Subject: Exelon Nuclear Texas Holdings, LLC
Victoria County Station
Early Site Permit Application
Environmental Report – Partial Response to ER RAI Letter No.14
Docket No. 52-042

Met-1 (eRAI No.6453):

Met-5 (eRAI No.6453):**NRC Request:**

Annual Wind Rose (July 1, 2007 through June 30, 2009)

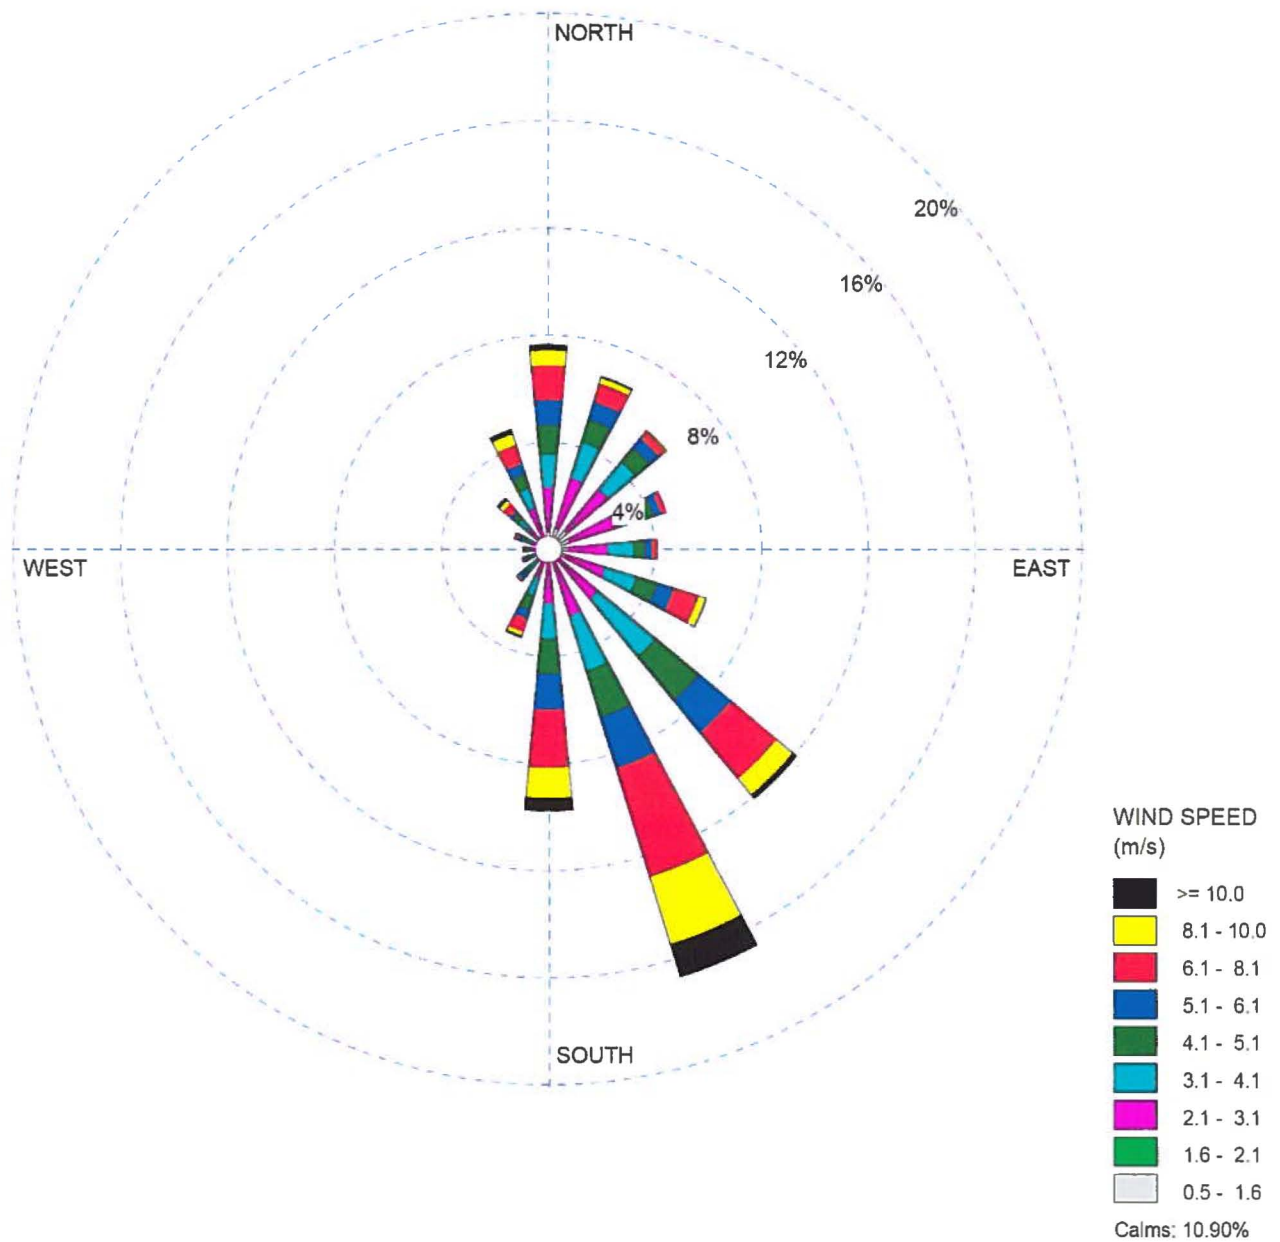
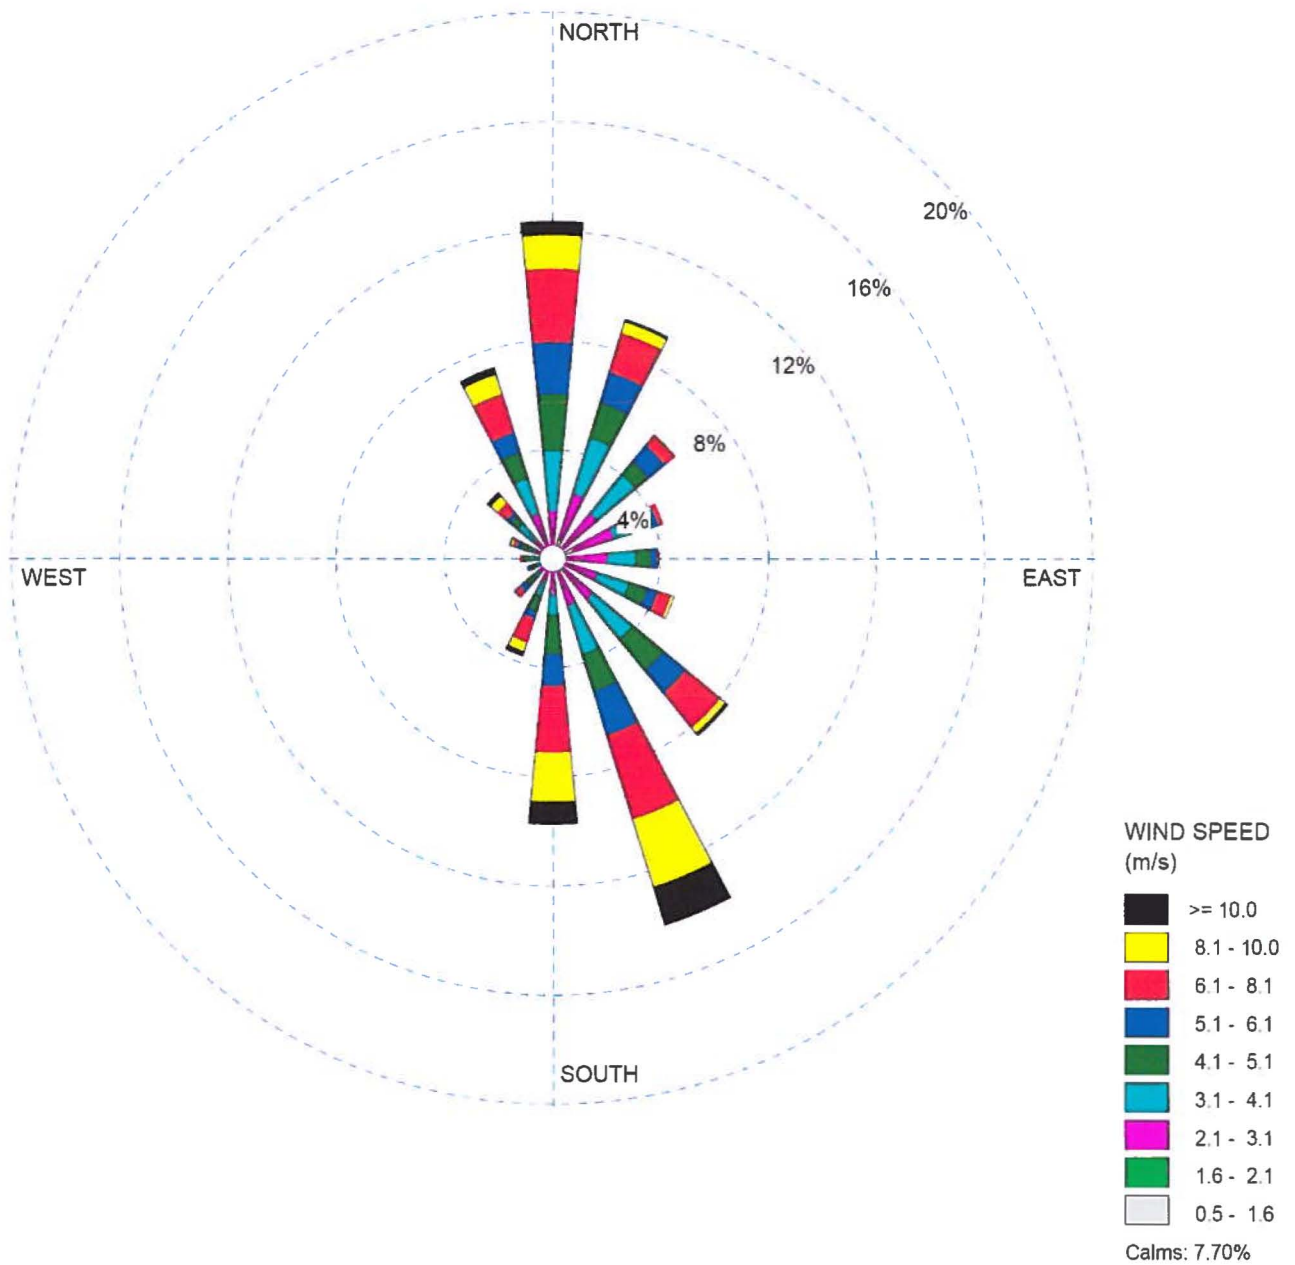
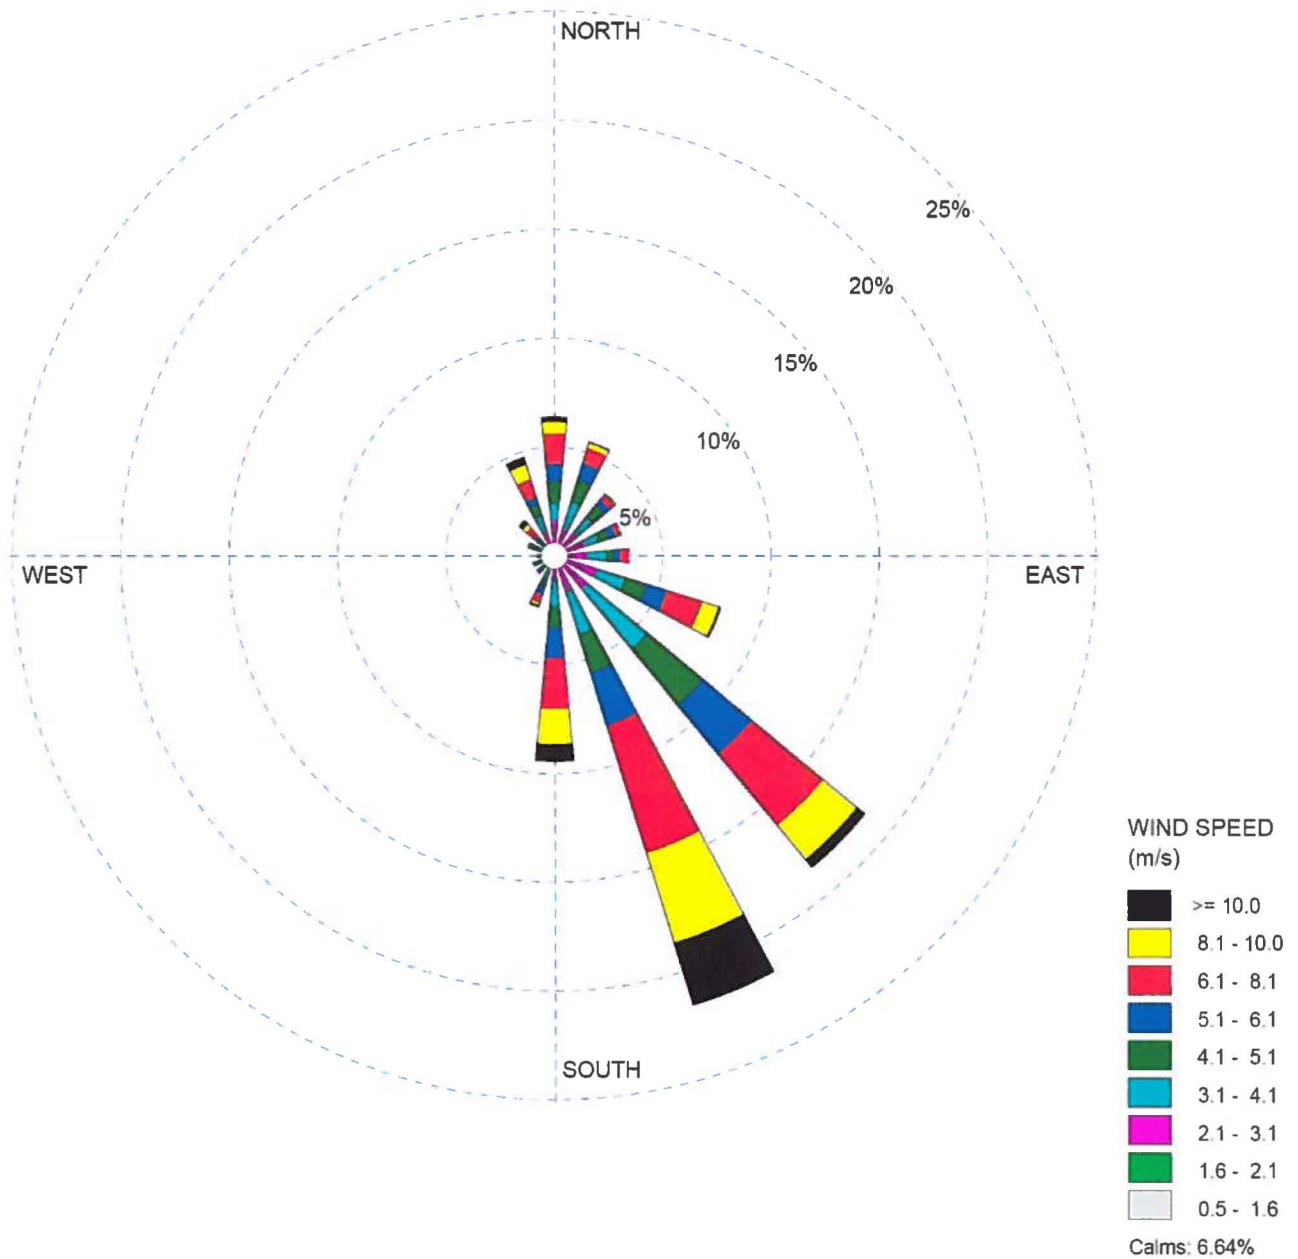
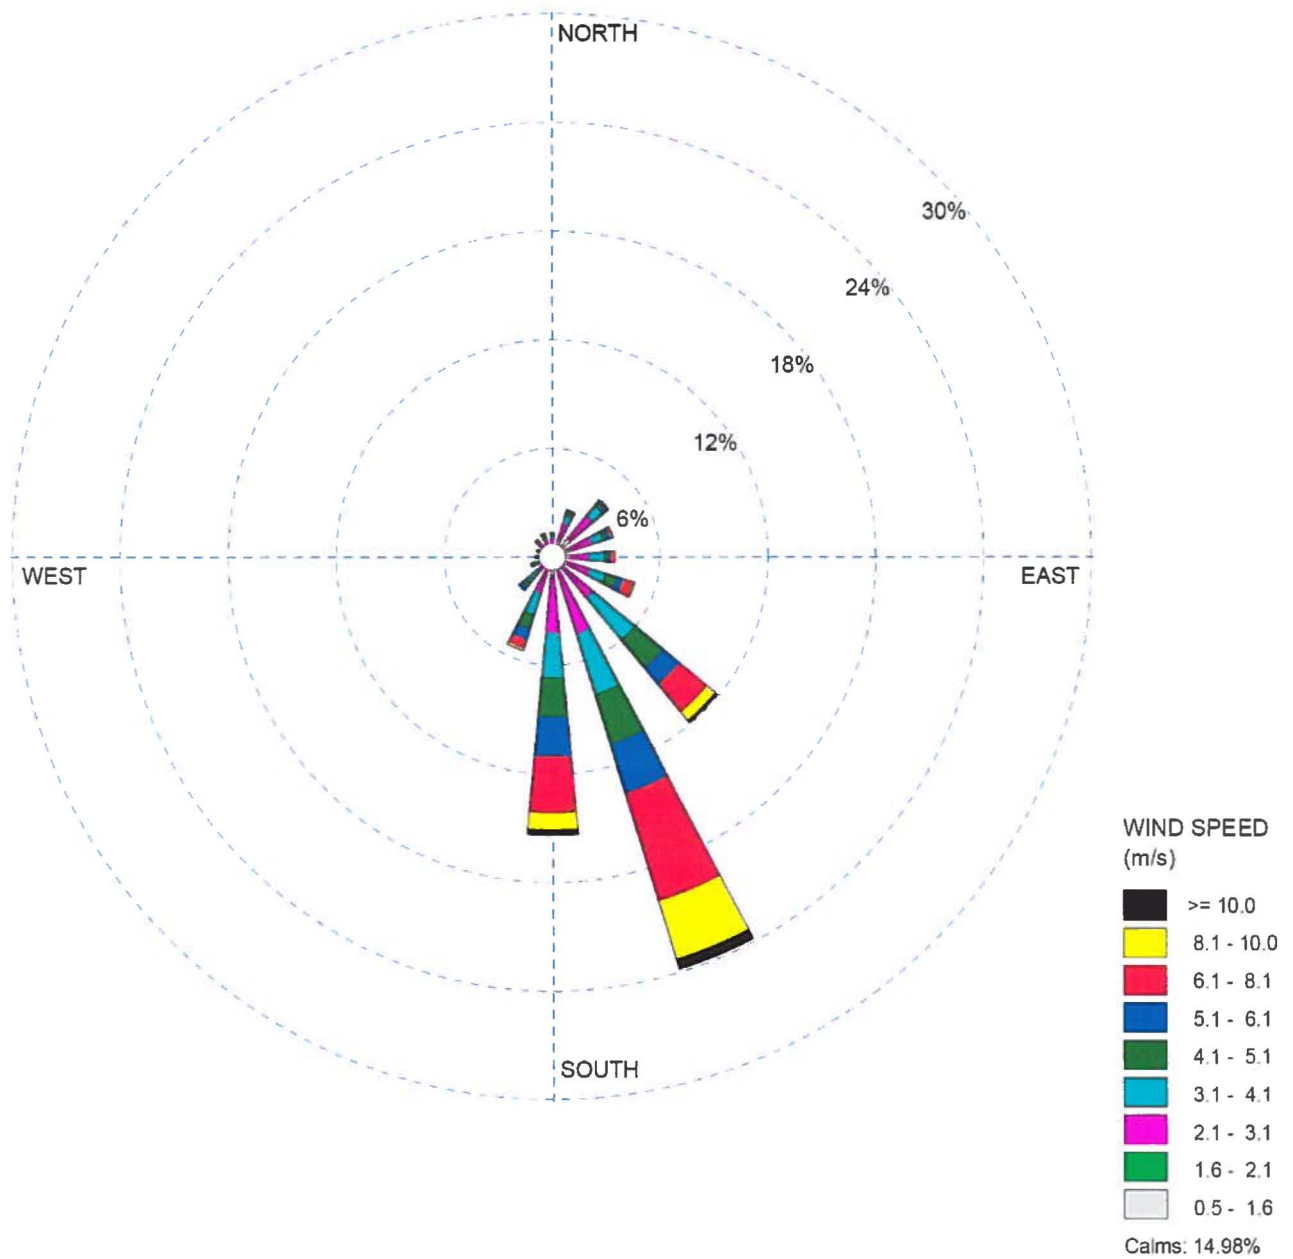
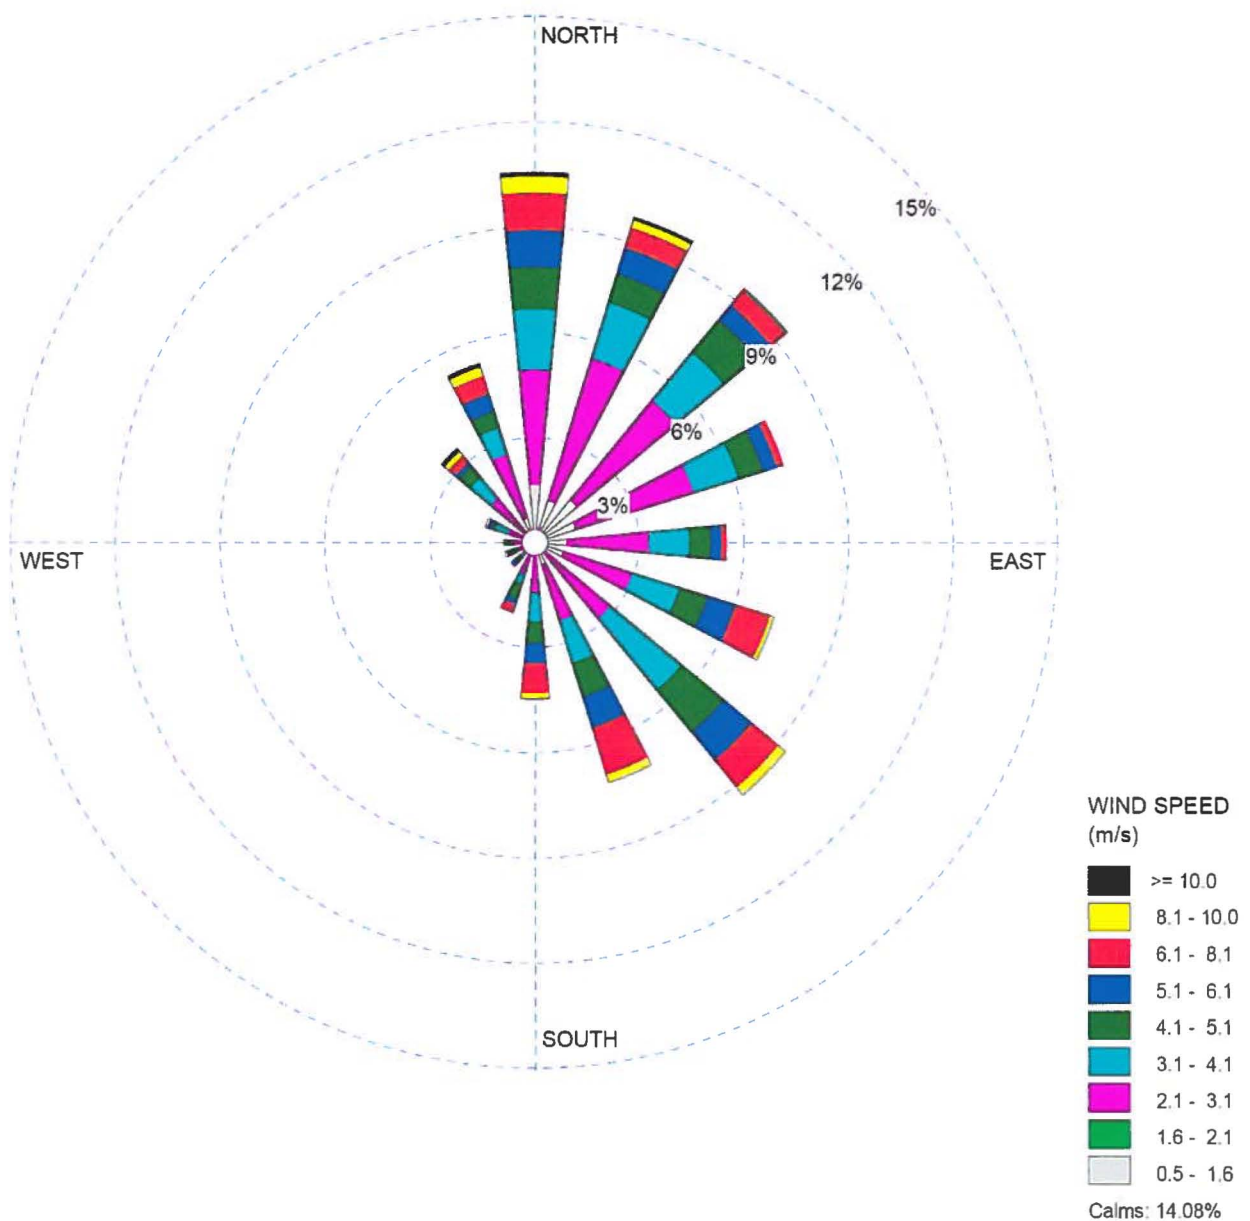
MET-1 - ESRP Section 2.7 directs the staff to review the applicant's meteorological monitoring program for obtaining data that are representative of the site. Section 2.7 (page 2.7-6) states "at least one annual cycle from the onsite meteorological program should be used to relate local meteorological conditions to local and regional climatology". In order to determine if the measurements taken at the VCS site are representative of the weather in the region, the NRC staff requests that the applicant provide annual and seasonal wind roses for Victoria National Weather Service (NWS) station for the same 2-year period as the onsite meteorological data, for comparison to the 10-meter onsite wind data. Provide annual and seasonal wind roses for Victoria NWS station for the same 2-year period as the onsite meteorological data.

Two years (July 1, 2007 to June 30, 2009) of data from the National Climatic Data Center's (NCDC) Integrated Surface Hourly (ISH) website (Ref. 1) were downloaded and converted into seasonal and annual wind roses. Annual and seasonal wind roses from the Victoria, Texas, (KVTC) (provided on the following pages) were compared to those in ER Figures 2.7-2 through 2.7-6 and were found to support the conclusion that measurements taken at the VCS site are representative of the weather in the region. The topography in this region is generally flat, so little variation is found between the two sites (ER Fig. 2.7-1).
